PRODUCT NEWS

Pilot Devices

Emergency stops - Design update

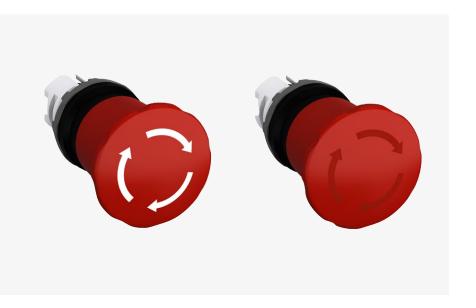
New design due to changes in standards

According to the new regulations in IEC 60947-5-5 emergency stops are no longer allowed to have markings or labels in white. When it is necessary to identify the direction of the unlatching of the actuator, this identification should have the same or nearly the same color as the actuator.

Because of these changes in regulations we have changed the design of both compact and modular range, illuminated and non illuminated, for both twist and pull release emergency stops during 2016. This changes that was implemented on the 1st of April 2016 will not affect the article numbers.
